# Service Bulletin

**Subject:** Deformed or Dimpled Liftgate Center Applique, Liftgate Paint Damage Evident at Lower Outer Edge of Applique

**Models:** 2007-2013 Chevrolet Suburban, Tahoe  
2007-2013 GMC Yukon Models, Yukon XL Models

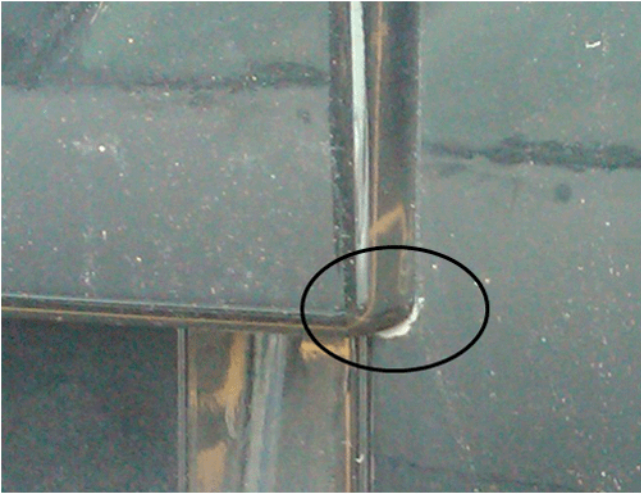
Some customers may comment on seeing a dimpling or deformation (shown circled above) near an outer edge of the liftgate center applique. The design of the applique might allow deformation or dimpling of the applique surface if the retaining nuts are overtightened. In some cases, damage to the applique mounting bosses may be evident if the studs were overtightened.

Some customers may comment on paint damage (shown circled above) on the liftgate at the lower outboard edges of the center applique. The design of the applique in conjunction with the forming of the license plate pocket in the liftgate may allow the lower outboard edges of the applique to have contact with the liftgate.

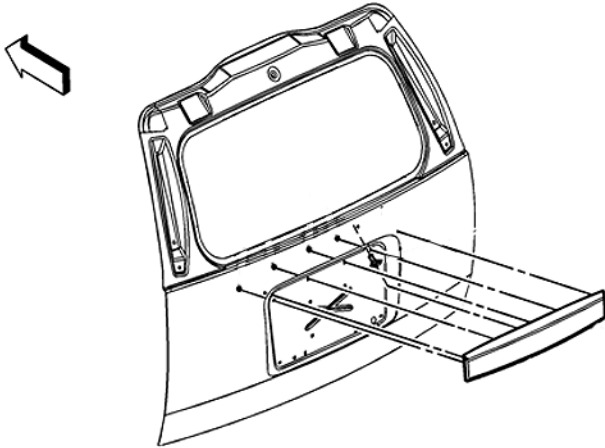
The liftgate center applique design has been revised to be more resistant to overtightening, provide enhanced anti-rotation measures for the mounting studs and also provide an improved interface to lessen contact with the liftgate.

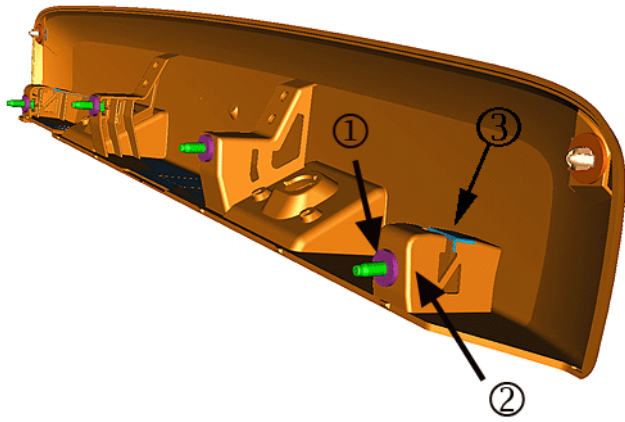
**Tip:** To correct Condition 2, the updated design applique is necessary, identified by a split along the top of the outer mounting boss locations (3). The updated design applique is already present on 2012 and new vehicles.

Additional clearance will need to be created between the lower edge of the updated applique design (3) and the liftgate. Add GM washer P/N 15911310 to the applique between the foam washer (1) and the mounting boss (2) at each of the four mounting stud locations. Stack the washers to obtain the needed amount of spacing along the lower edge of the applique to prevent contact to the liftgate, while providing a good appearance.
